SECTION 9

Louisiana Department of Natural Resources and U.S. Environmental Protection Agency Review

MISSISSIPPI RIVER REINTRODUCTION INTO BAYOU LAFOURCHE
LOUISIANA DEPARTMENT OF NATURAL RESOURCES
PHASE 1 DESIGN REPORT

FIGURE 9-1
WATER SURFACE PROFILES
SEVEN REMAINING ALTERNATIVES
BAYOU LAFOURCHE CHANNEL
 MISSISSIPPI RIVER REINTRODUCTION INTO BAYOU LAFOURCHE
 LOUISIANA DEPARTMENT OF NATURAL RESOURCES
 PHASE 1 DESIGN REPORT

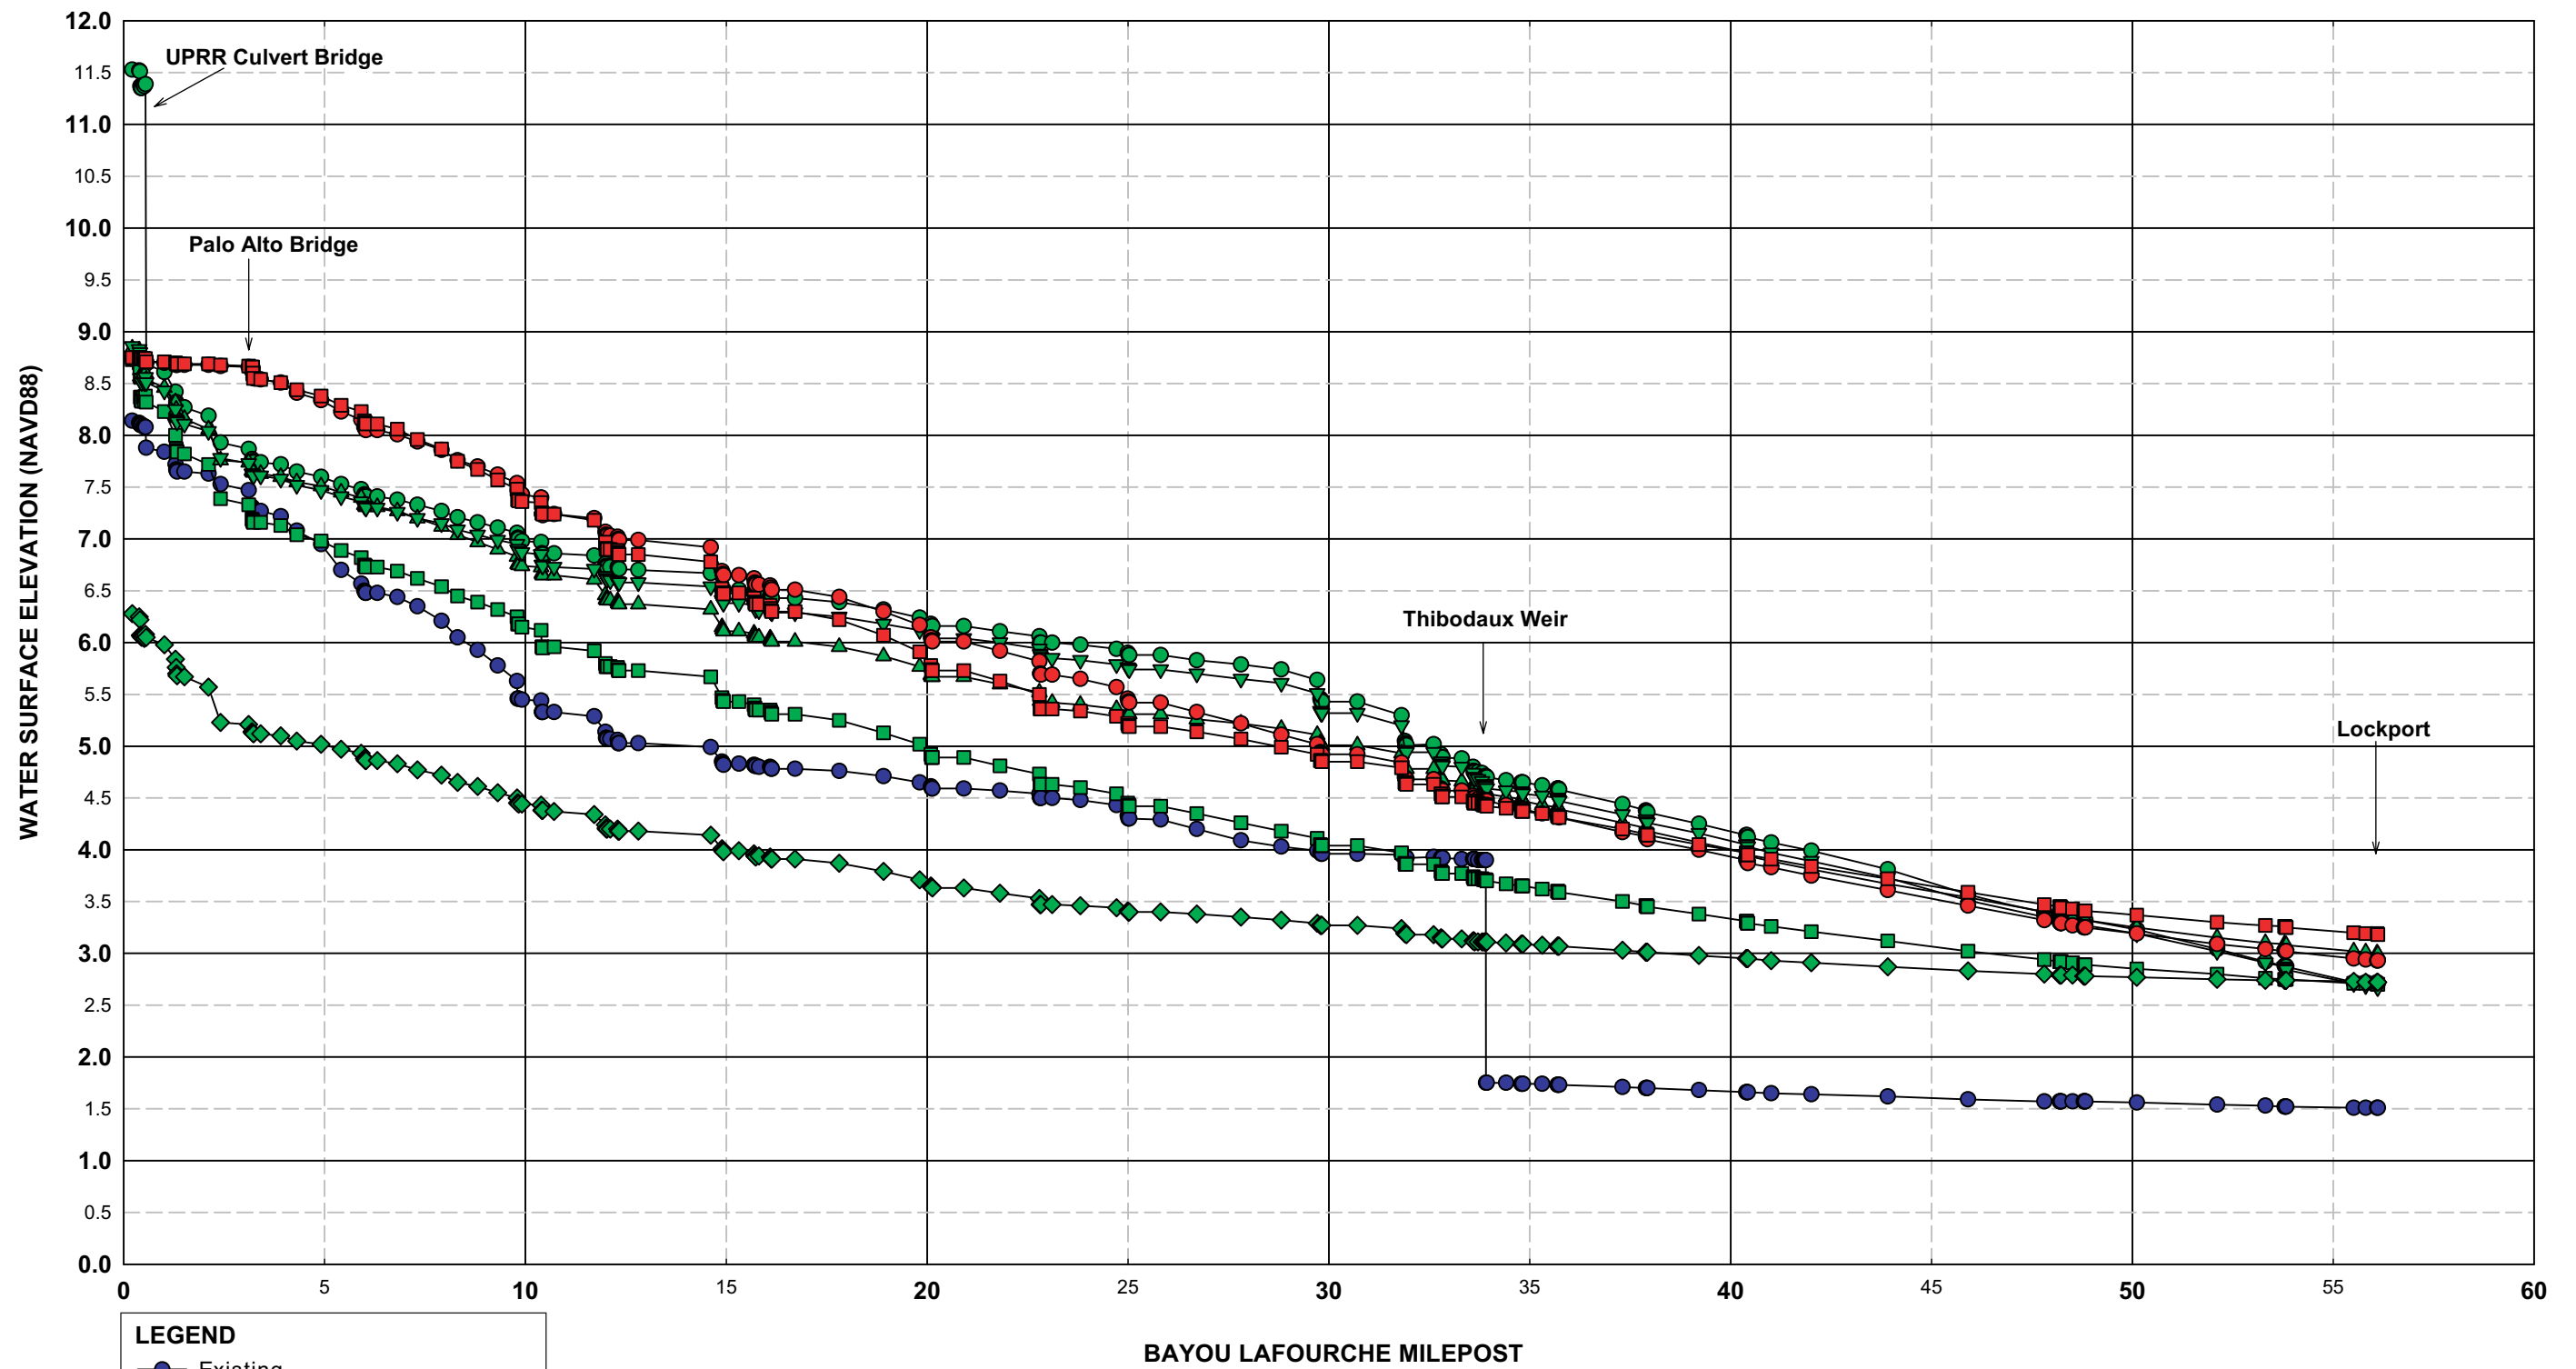
During the review of the Draft Final Phase 1 Report, LDNR and EPA requested that Alternative 20 and the least rise alternative be included in the set of remaining alternatives discussed in Section 8. The purpose of adding these two alternatives was based on concerns about public reaction regarding the impacts of the water level rise compared with the five recommended alternatives in Section 8.

Each of the two alternatives, 20 and least rise, has a diversion flow of about 1,000 cfs. The water level rise through Donaldsonville for Alternative 20 is approximately 0.5 foot less than the three alternatives using the Donaldsonville pump station (15, 32, and 38), and nearly 1.0 foot less than the two alternatives using the Smoke Bend pump station (44 and 47). The least rise alternative water level is actually below the existing water level in Donaldsonville because of the 8-foot dredging.

For the least rise alternative, impacts associated with decreased water levels (e.g., low-water impacts to boat docks and ramps) could be mitigated by use of a check structure/rubber dam to artificially raise water levels in the Donaldsonville reach. Figure 9-1 shows the water level profiles for the seven alternatives.

In the Thibodaux area, the water level for the two additional alternatives is approximately 0.5 foot lower for Alternative 20 and about 1.5 feet lower for the least rise as compared to the group of five alternatives discussed in Section 8 (this varies depending on the distance downstream of the weir, see Figure 9-1). Neither Alternative 20 nor the least rise alternative will provide a water surface lower than existing water levels downstream of Thibodaux because of the tailwater conditions and increased flow. The water level rise below Thibodaux for the seven alternatives ranges from 1.4 to 3.0 feet. The 3.0-foot rise is only at the location immediately downstream of the existing weir, and the water level rise above existing levels decreases downstream of the weir.

**FIGURE 9-2
COST-EFFICIENCY PLOT OF
SEVEN REMAINING ALTERNATIVES**

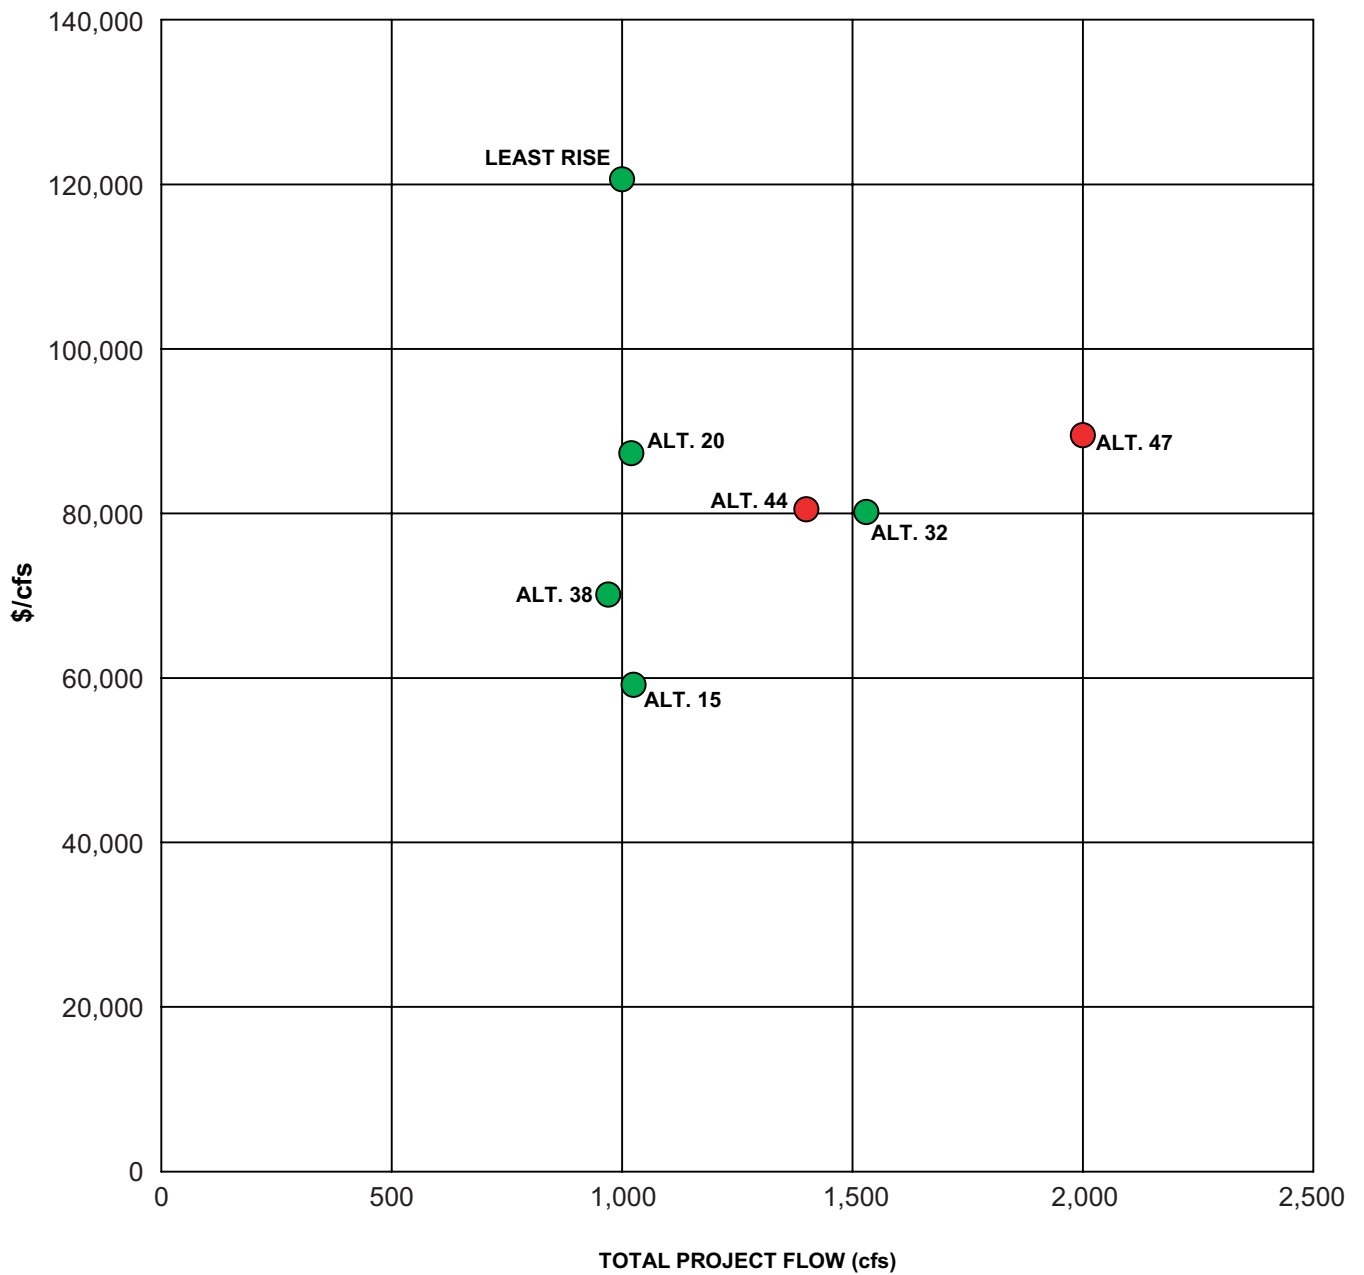
Table 9-1 shows the major attributes of the seven alternatives recommended by LDNR and EPA to be carried into the 30 percent design. The unit costs range from \$59,000/cfs to \$121,000/cfs. Figure 9-2 shows a graphical distribution of the alternatives' unit cost compared with diversion flow. The trend of the five recommended alternatives from Section 8 is up-and-to-the-right showing slightly increasing unit cost for the added flow. Four alternatives have flow capacities of about 1,000 cfs, with unit costs from \$59,000/cfs to \$121,000/cfs.
